UNITED STATES PATENT AND TRADEMARK OFFICE

APPLICATION NO.	FILING DATE	FIRST NAMED INVENTOR	ATTORNEY DOCKET NO.	CONFIRMATION NO.
10/698,382	11/03/2003	Chang-Bong Choi	IK-0068	2720

Office Action Summary	Application No. 10/698,382	Applicant(s) CHOI, CHANG-BONG	
	Examiner Timothy M. Ayres	Art Unit 3637

DETAILED ACTION

Lee '805 Figure 6

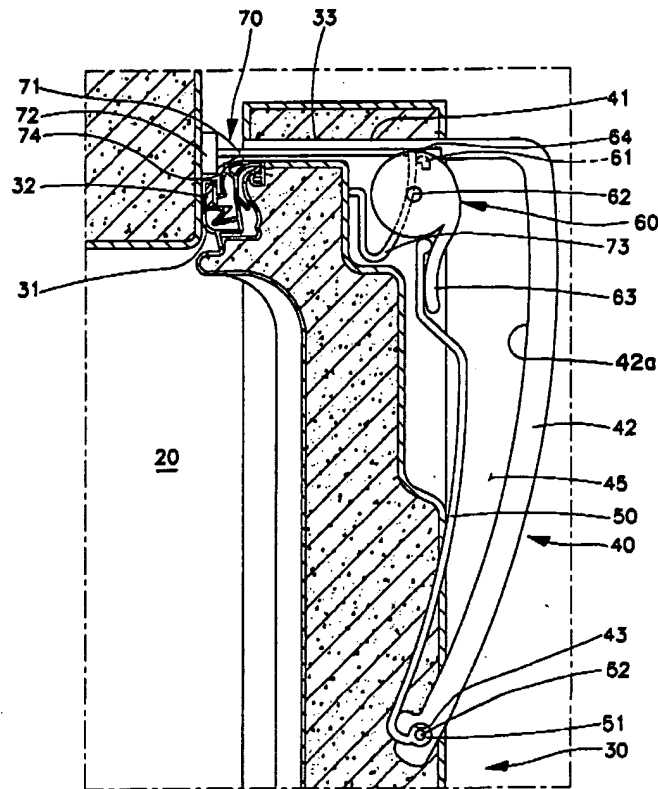
5,915,805 to Lee. The prior art (fig. 1, 2a, 2b, 2c) discloses a drawer body (3) that slides in and out on drawer rails (9). A door (2) is connected to pin (7), which is the axis of rotation. The door (2) has a gasket (8) around the edge that comes in contact with the main refrigerator body (1) when the door is closed. The gasket (8) is formed below the axis of rotation (7). The drawn prior art does not disclose expressly a cushion member or a plurality of cushion members that prevents contact of the gasket with the main body of the refrigerator when the door pivots on the axis of rotation and that is installed on the door of the refrigerator. Lee '805 discloses a refrigerator door (30) with a handle (40). A cushioning member (72) is towards the outside edge of the door side of the gasket (31), in figure 6 this side is above. The cushioning member (72) is attached to the handle (40) such that when the door pivots, the gasket (31) is prevented from contact with the main body of the refrigerator (10).

For 1, 3, and 4, at the time of the invention it would have been obvious for a person of ordinary skill in the art to take the drawn prior art in this application and add the cushion member (72) of Lee '505 to the door of the refrigerator or to install it on main body of the refrigerator below the gasket, since below is side of the outside edge of the door, in order to prevent compression of the gasket between the door and the main body of the refrigerator and to make the door easier to open.
